Freightliner
Service Bulletin

Description of Revisions: *This service bulletin replaces the previous version dated May 1999. A measurement error is corrected.*

Business Class FL112 vehicles equipped with a Caterpillar C10 or C12 engine, and built before November 13, 1998, may have a problem with interference between the underside of the hood and the petcock valve on the upper radiator pipe. See **Fig. 1** and **Fig. 2**.

Fig. 1, Upper Radiator Pipe Location (top view)

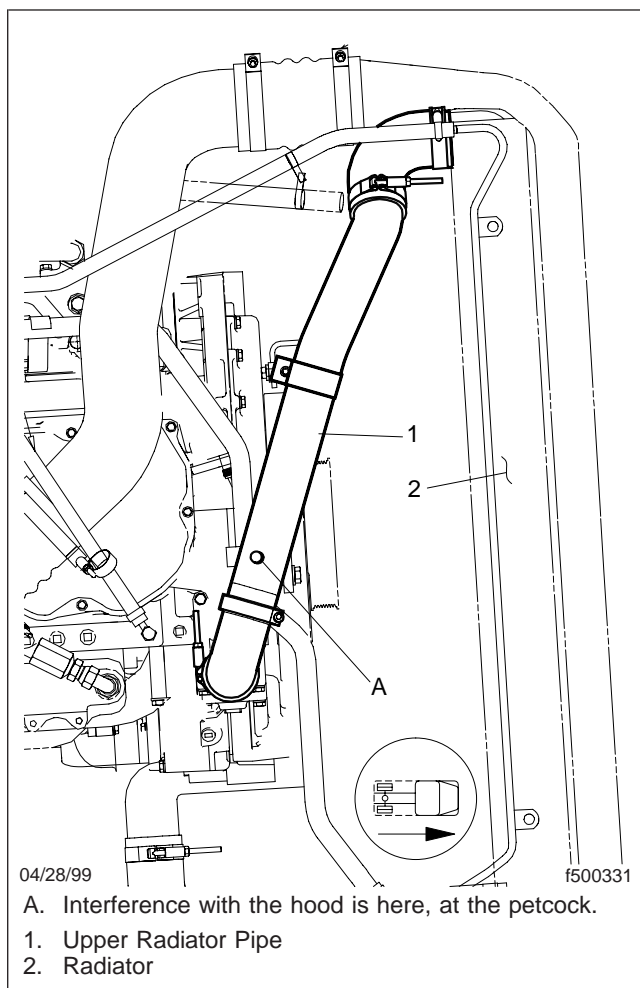
This interference can result in a wear mark on the underside of the hood from the petcock contacting it. The problem may be caused by the upper radiator pipe not being fully seated, or an incorrectly adjusted hood.

Affected vehicles must be checked for correct clearance between the petcock on the upper radiator pipe and the underside of the hood. Use the procedure below to check the clearance.

Fig. 2, Upper Radiator Pipe Location (side view)

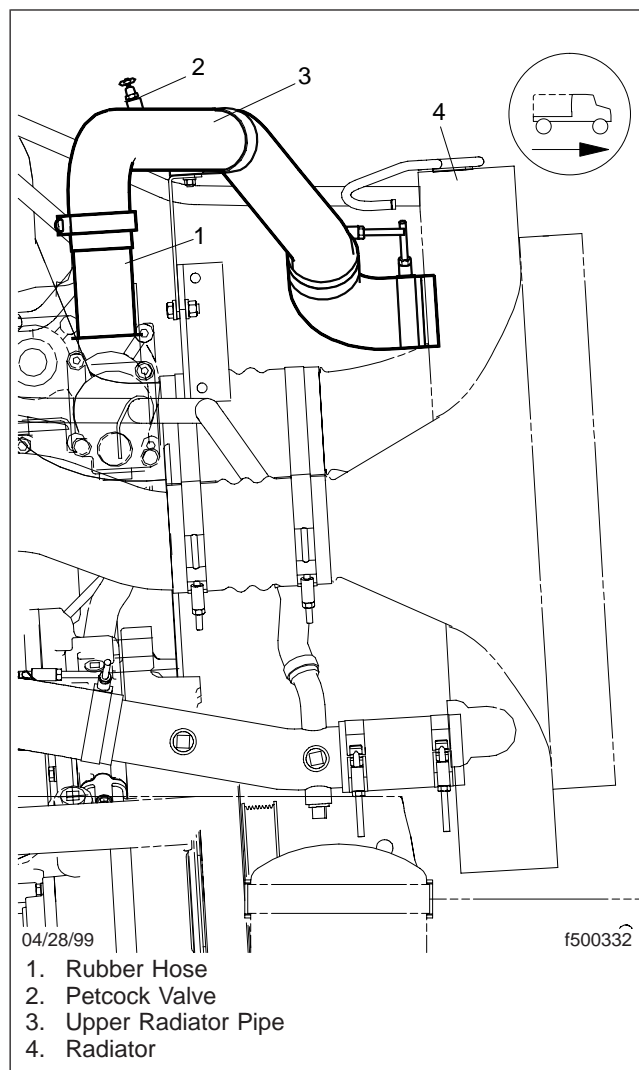
4. If there is evidence of wear on the underside of the hood, check the gap between the end of the upper radiator pipe and the thermostat housing.
 - 4.1 Loosen the clamp holding the rubber hose to the end of the radiator pipe. See [Fig. 2](#).

- 4.2 Push the radiator pipe down inside the hose until it contacts the thermostat housing.
 - 4.3 Pull up on the radiator pipe until there is a minimal gap (about 1/4-inch or 6 mm) between the end of the pipe and the thermostat housing. The pipe and the housing should not be touching.

- 4.4 Tighten the clamp firmly.
5. Put a 3/4 inch (19 mm)-diameter ball of soft putty on top of the petcock. Then lower the hood and latch it.
6. Tilt the hood. Then, check the ball of putty.
